STAFF RECOMMENDATION
300 Broadway
June 21, 2017

Application: Signage
District: Broadway Historic Preservation Zoning Overlay
Council District: 19
Map and Parcel Number: 09306308200
Applicant: Janie Wright, Tuck Hinton Architects
Project Lead: Robin Zeigler, robin.zeigler@nashville.gov

Description of Project: The project includes three wall signs (sign numbers 2, 3 and 4), two projecting signs (sign 1 and 5), and two painted wall signs (signs 6 and 7). **Recommendation Summary:** Staff recommends approval, finding the project to meet the design guidelines for signage in the Broadway Historic Preservation Zoning Overlay.	**Attachments** **A:** Drawings

Sign 1: Projecting

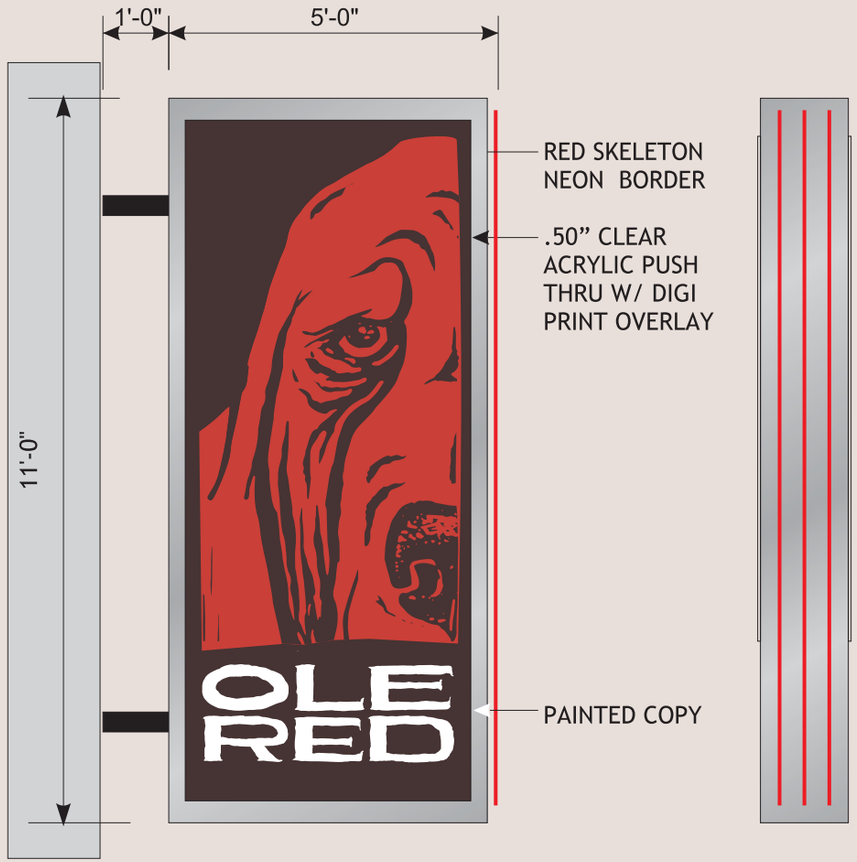
Dimensions: The projecting sign (sign 1) is well below the twenty-foot (20') maximum height at eleven feet (11'), is one-foot (1') from the façade, does not project more than six feet (6') and meets the cabinet depth requirements.

The projecting signs (signs 1 and 5) are appropriate locations because they are more than twenty-five feet (25') from the closest projecting sign, they are located below the window sills of the third story, they do not extend above the building parapet and it do not cover architectural details.

Illumination: Signs 1, 4 and 5 have internal illumination. The background is opaque with the text and the logo having internal illumination. Signs 2 and 3 have backlighting of the lettering only with a clear background.

Sign 2: Wall

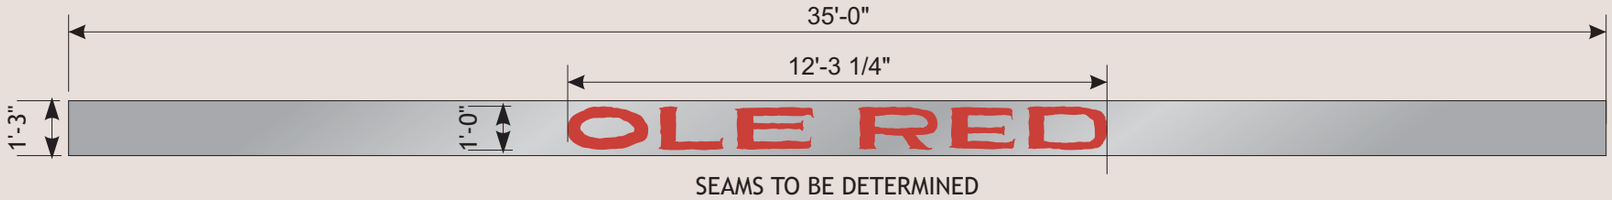
Wall sign 4 has a depth of thirteen feet (13") which meets the requirement for signage with internal illumination. Wall signs 2 and 3 have a depth of six inches which is greater than the two inches allowed. Staff finds the additional depth to be appropriate because it is used to create a clear "window" over the existing historic signage on the front of the

<u>Location</u>: The front wall sign (sign 2) would generally not be in an appropriate location because it covers an architectural feature, the original name of the building. The building was constructed in 1911, after the Broadway Bank & Trust, changed to the Broadway National Bank. The 1912 City Directory notes the building as the Broadway National Bank. Architect, Edwin Keeble redesigned the first and mezzanine levels in 1947. His drawings do not show signage in this location so it is believed that the signage from 1911 remains. The building was remodeled in 1999 using Federal tax credits. The application for the credits does not mention any alterations to signage. Staff was unable to determine the material of the signage from the street; however, the applicant believes it to be metal, possibly bronze. Staff finds the location to be appropriate because the design of the sign, letters on a clear background will allow the original sign to be seen, similar to what is seen at the L&C Tower, but more appropriately scaled for this smaller building.
